W-1 LEON CREEK: HWY 151 TO HWY 90 - UPPER SEGMENT

Solicitation Number: CO-00351

Job No.: 19-4528

ADDENDUM 1

SAWS JOB NO. 19-4528
W-1 LEON CREEK: HWY 151 TO HWY 90
UPPER SEGMENT
QUANTITIES AND SAWS GENERAL
CONSTRUCTION NOTES SHEET

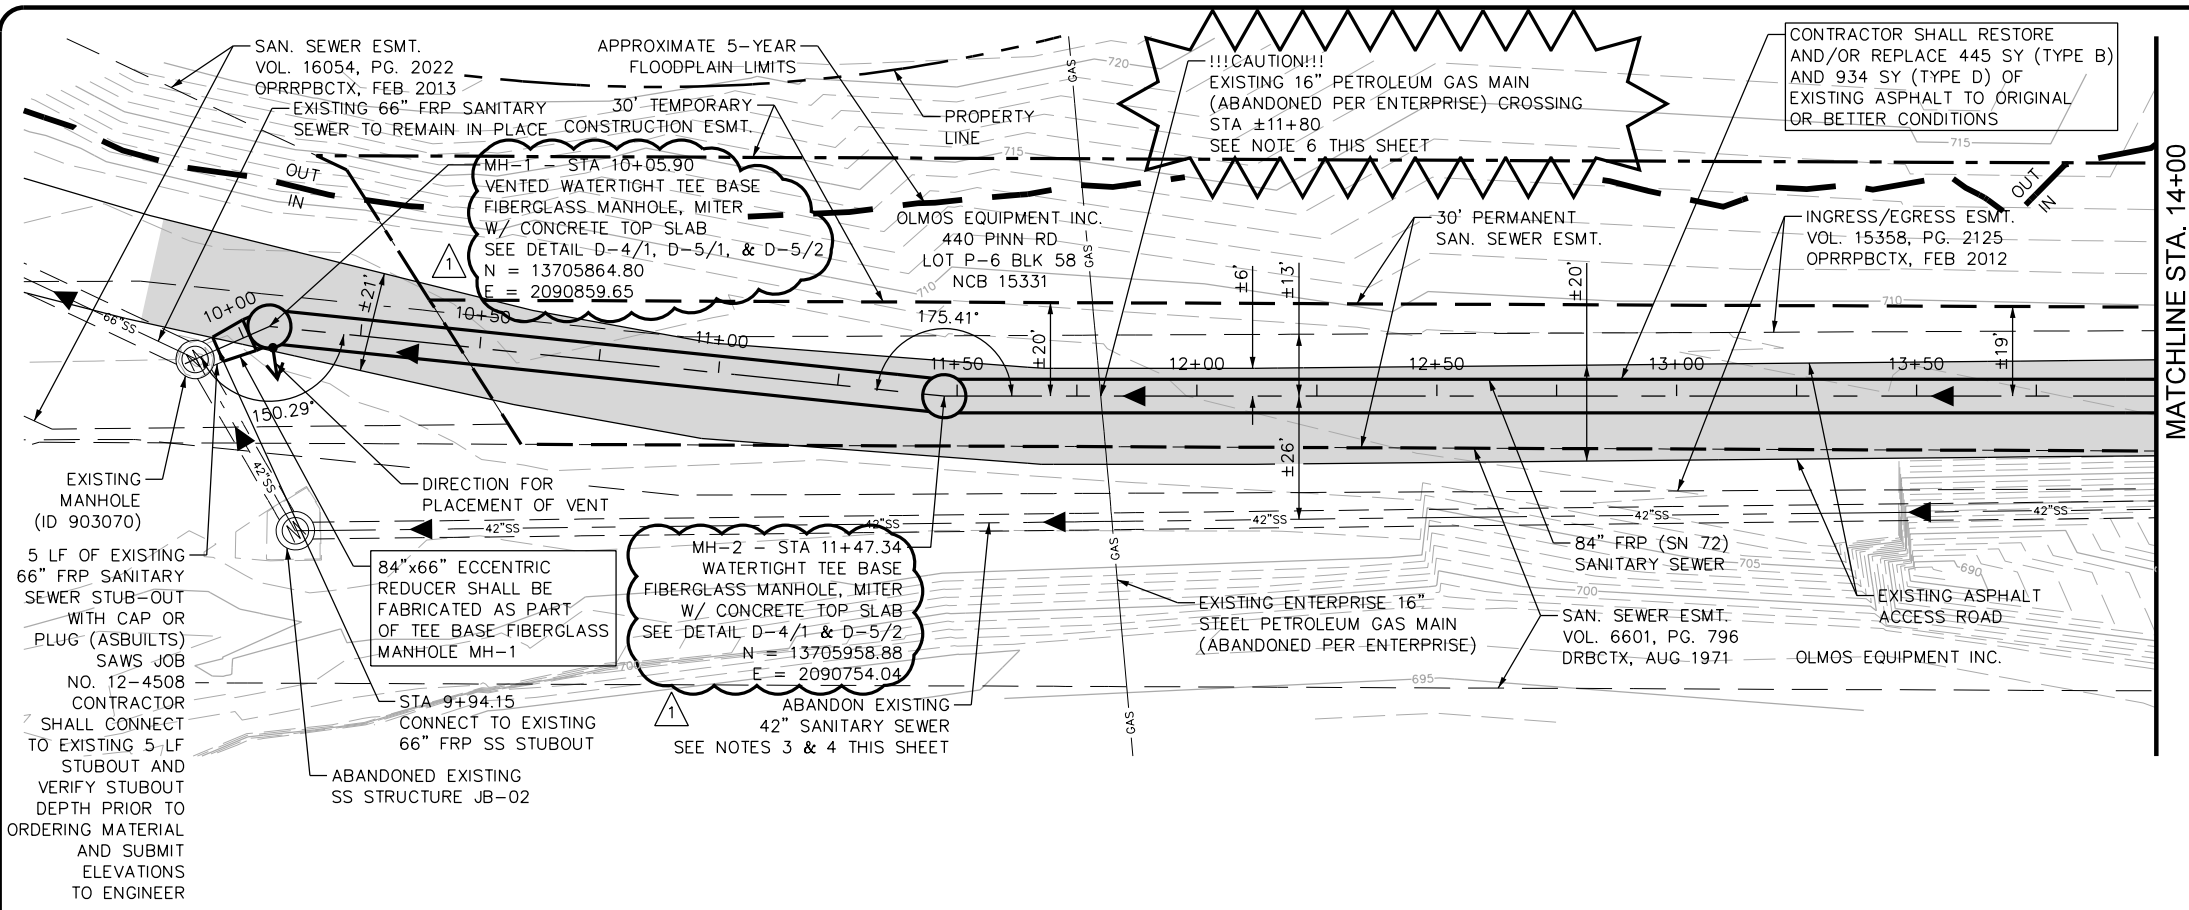
1. Remove the following plan sheets in their entirety and replace them with the attached, revised plan sheets. (Revisions made from the original sheets are depicted by revision clouds around the changed portions.)
 - Sheet G-4: QUANTITIES AND SAWS GENERAL CONSTRUCTION NOTES SHEET – Replace sheet in its entirety.
 - Reduce quantity of Line Item 39 – Extra Depth Tee Base Manhole
 - Added Line Item 69 – Concrete Manhole Top Slab
 - Revised Excavation Equipment note to indicate that rock excavation is considered incidental to the pipe installation and there is no separate line item.
 - Sheet C-1: Line “A” Plan and Profile Sheet STA 9+94.15 to 14+00 – Replace sheet in its entirety.
 - Added concrete top slabs to MHs 1 and 2
 - Added Line Item D-5 – Concrete Manhole Top Slab to Quantity Table

SAWS JOB NO. 19-4528
W-1 LEON CREEK: HWY 151 TO HWY 90
UPPER SEGMENT
LINE "A" PLAN AND PROFILE
STA 18+00 TO STA 22+00

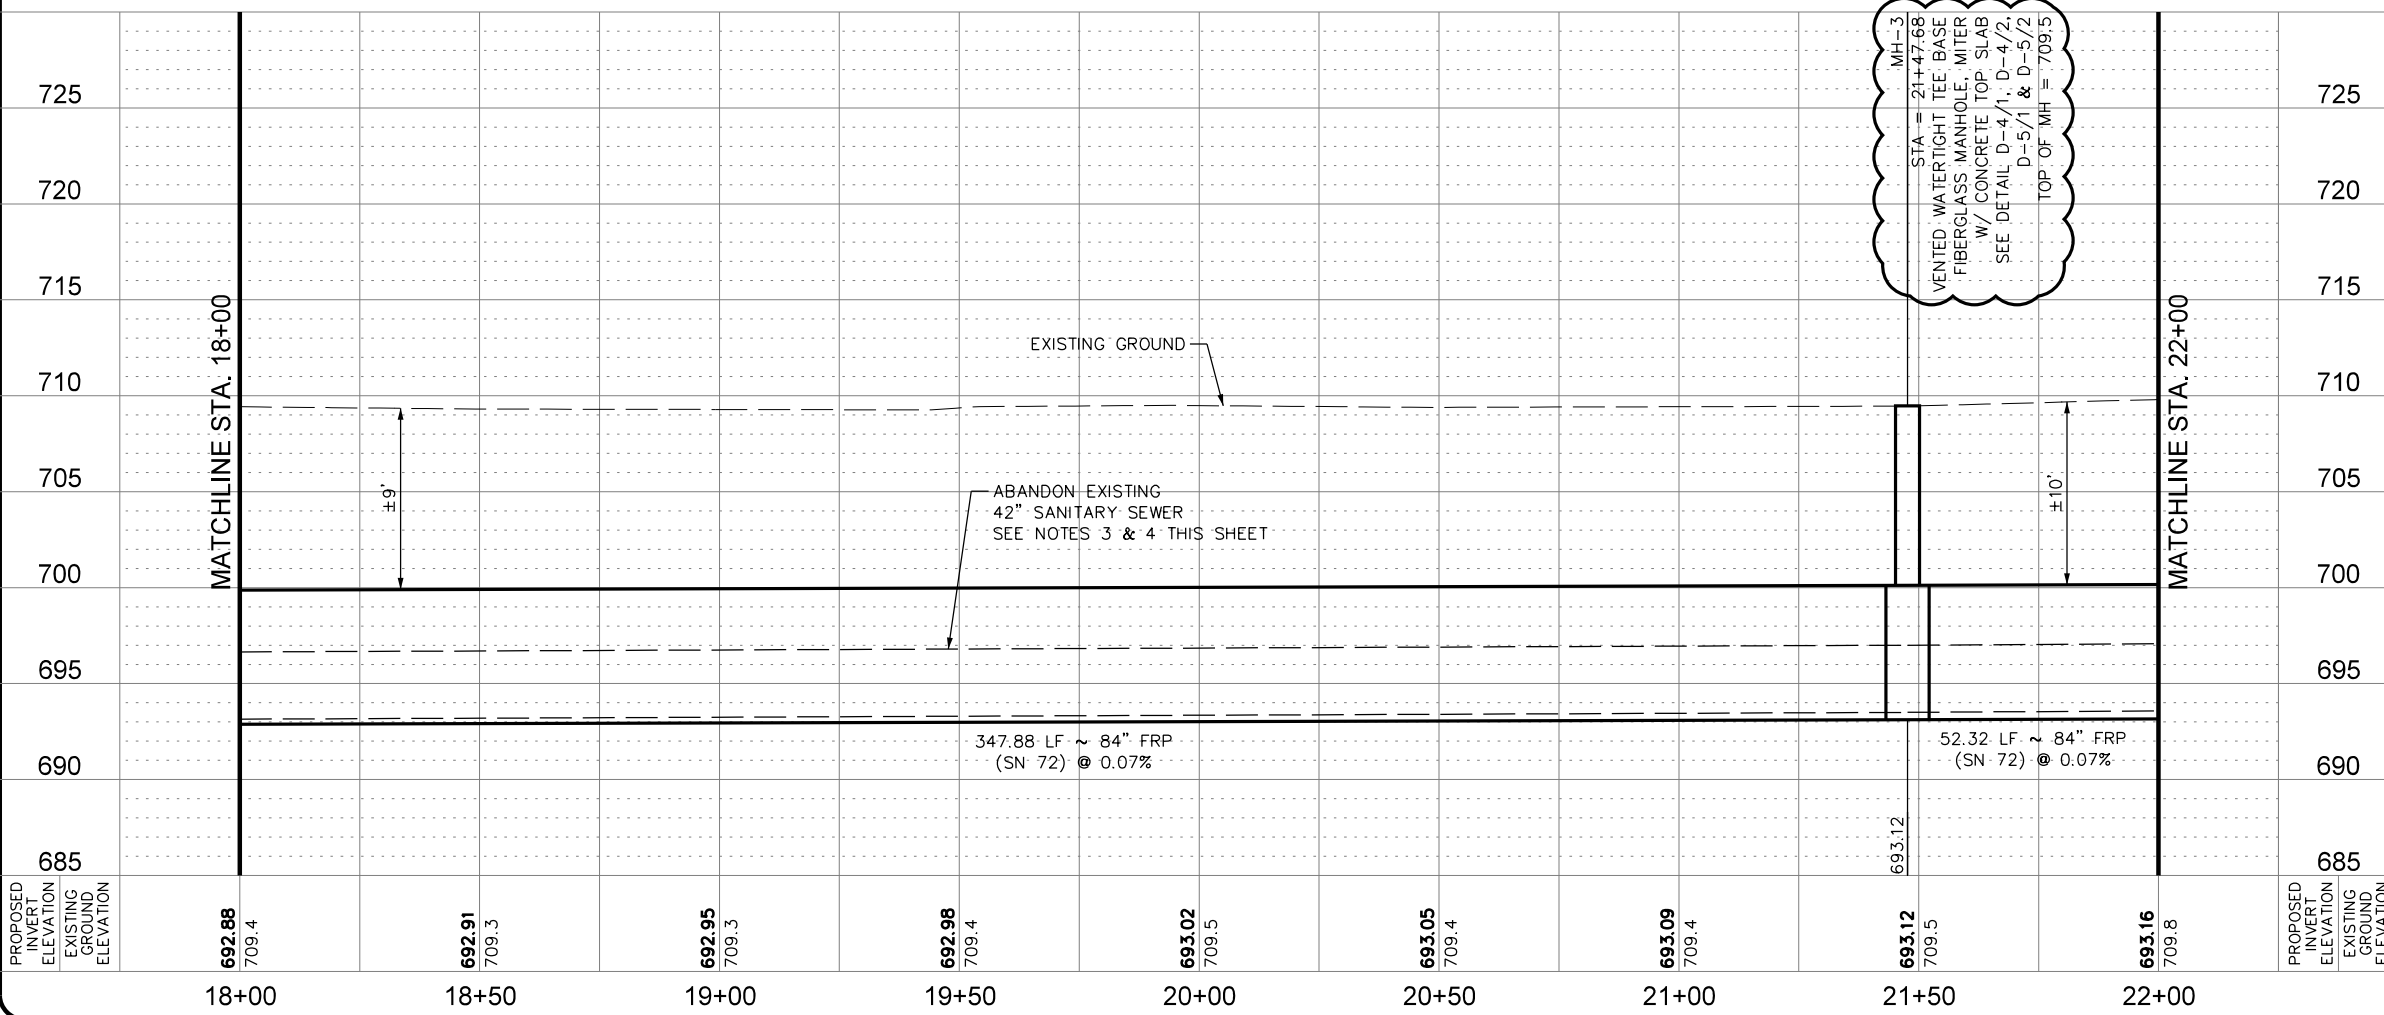
- Sheet C-3: Line “A” Plan and Profile Sheet STA 18+00 to 22+00 – Replace sheet in its entirety.
 - Added concrete top slab to MH-3
 - Added Line Item D-5 – Concrete Manhole Top Slab to Quantity Table

SAWS JOB NO. 19-4528
W-1 LEON CREEK: HWY 151 TO HWY 90
UPPER SEGMENT
LINE "A" PLAN AND PROFILE
STA 30+00 TO STA 34+00

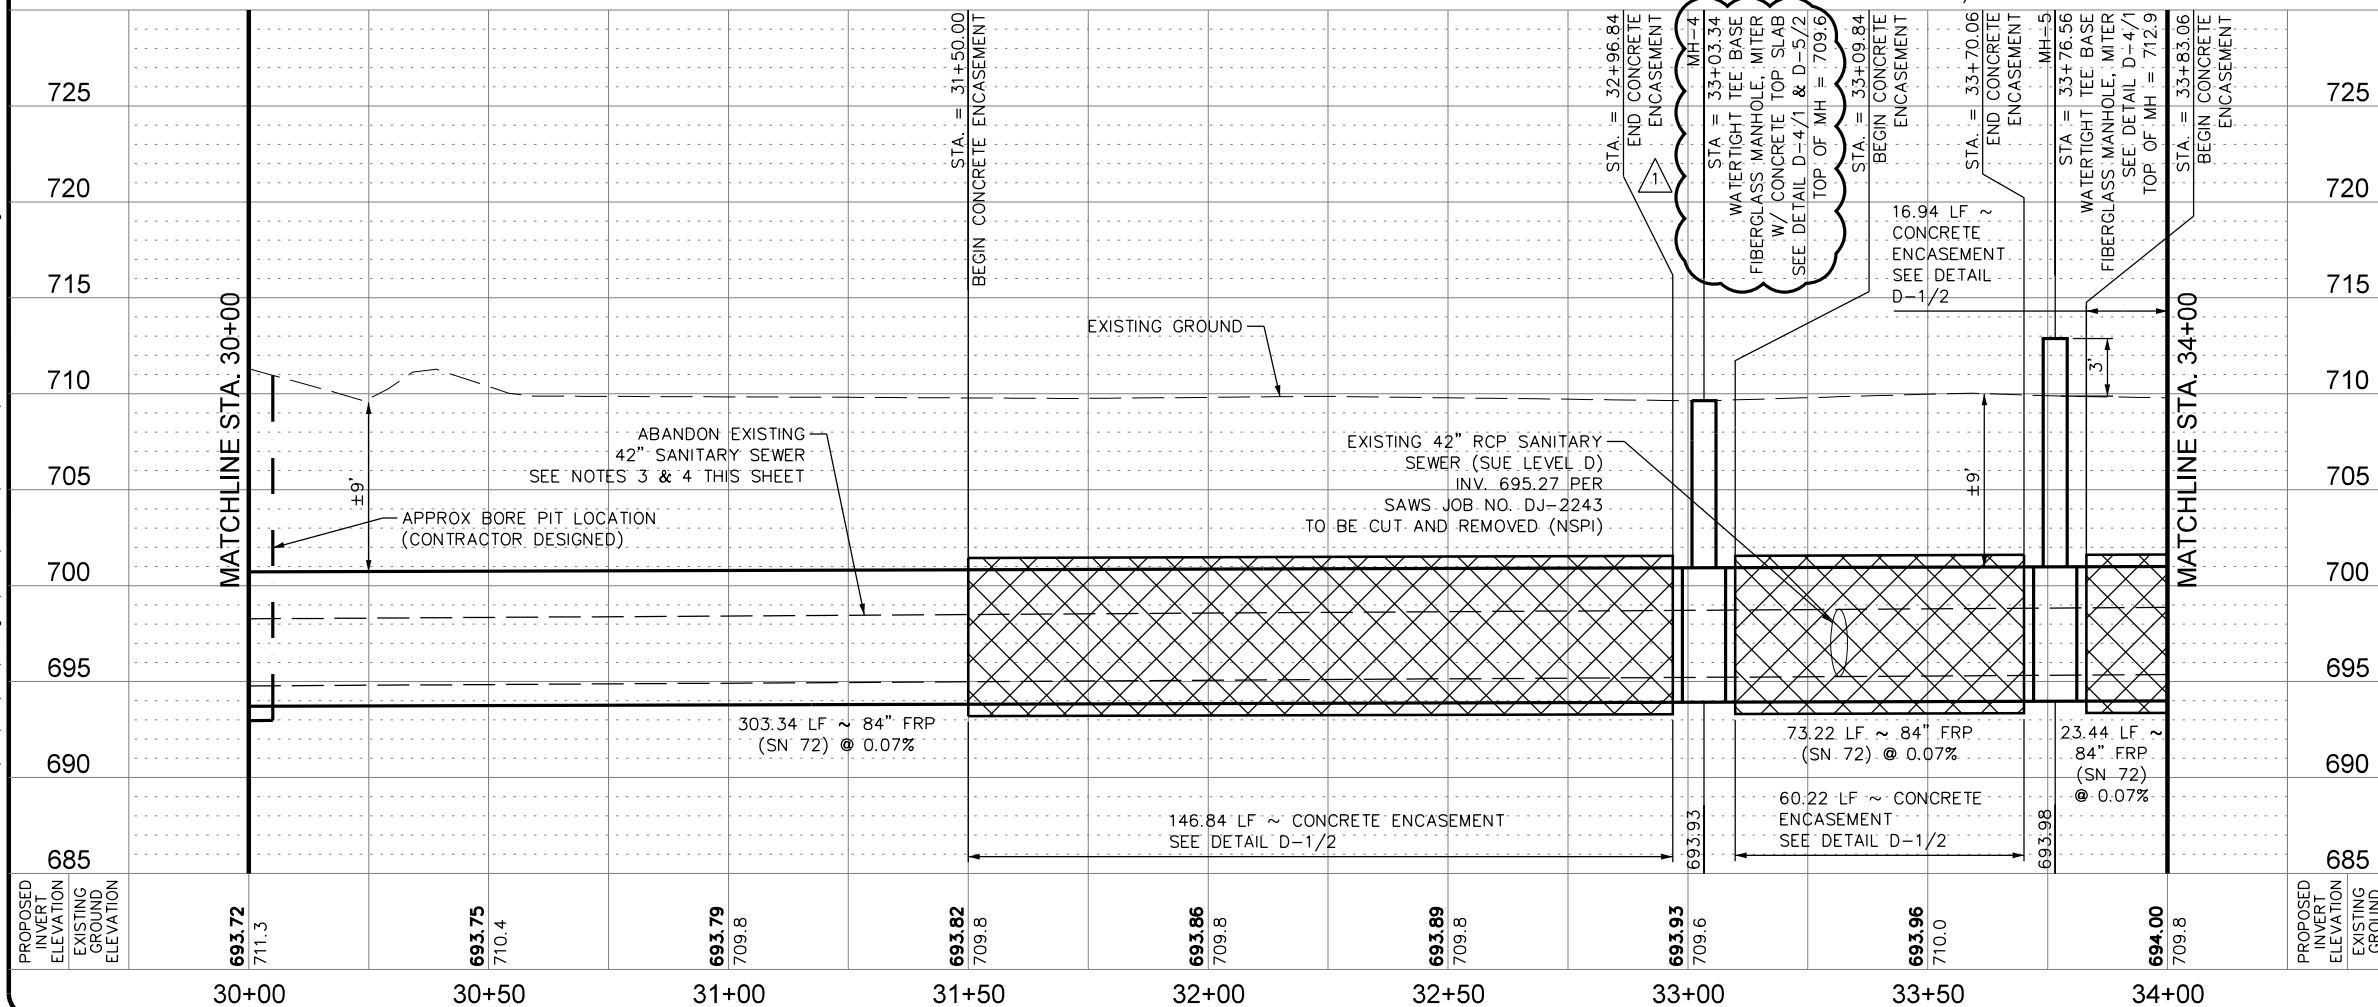
- Sheet C-6: Line “A” Plan and Profile Sheet STA 30+00 to 34+00 – Replace sheet in its entirety.
 - Added concrete top slab to MH-4
 - Added Line Item D-5 – Concrete Manhole Top Slab to Quantity Table

SAWS JOB NO. 19-4528
 W-1 LEON CREEK: HWY 151 TO HWY 90
 UPPER SEGMENT
 LINE "A" PLAN AND PROFILE
 STA 42+00 TO STA 46+00

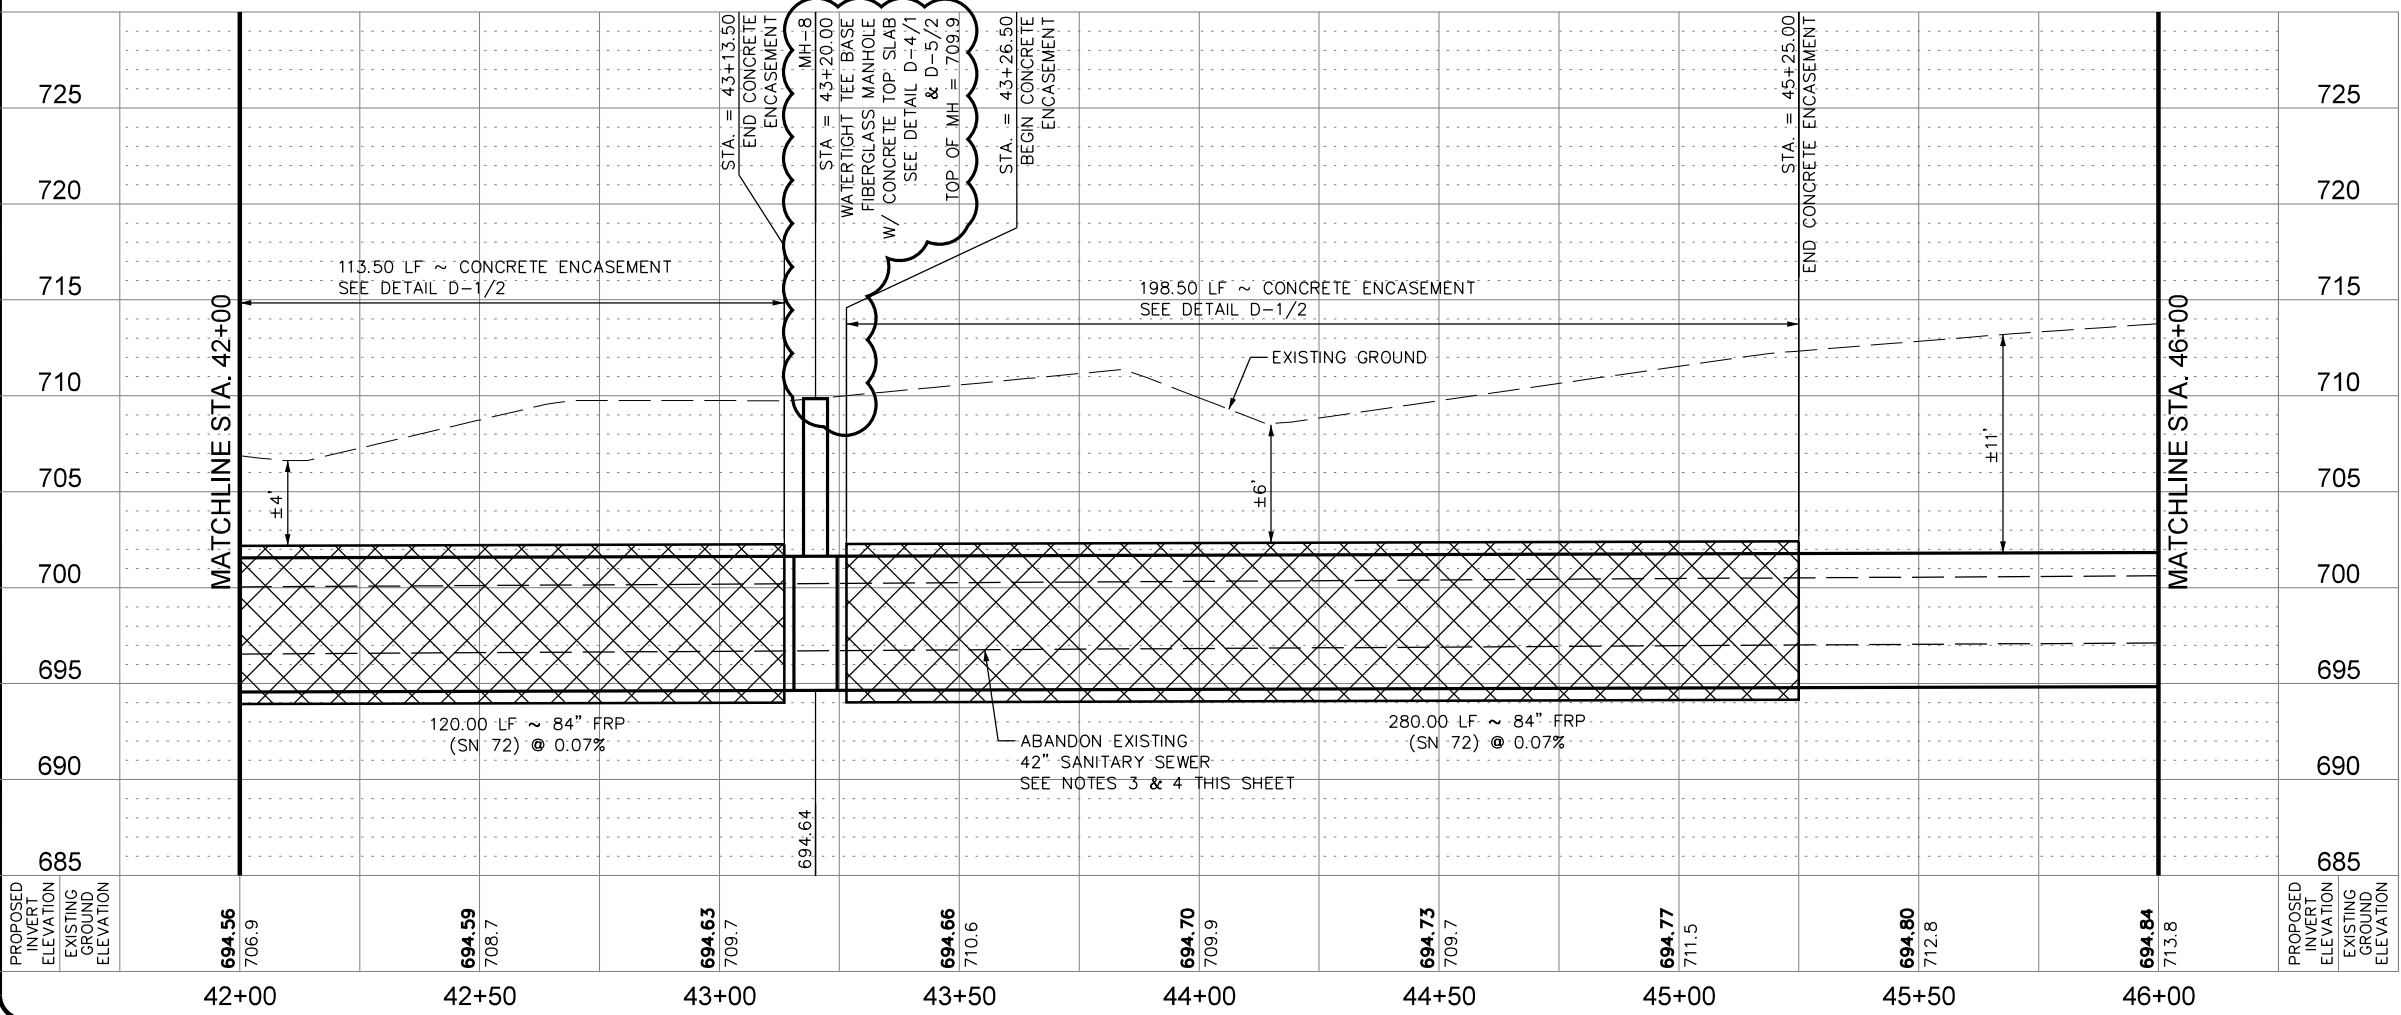
- Sheet C-9: Line “A” Plan and Profile Sheet STA 42+00 to 46+00 – Replace sheet in its entirety.
 - Added concrete top slab to MH-8
 - Added Line Item D-5- Concrete Manhole Top Slab to Quantity Table
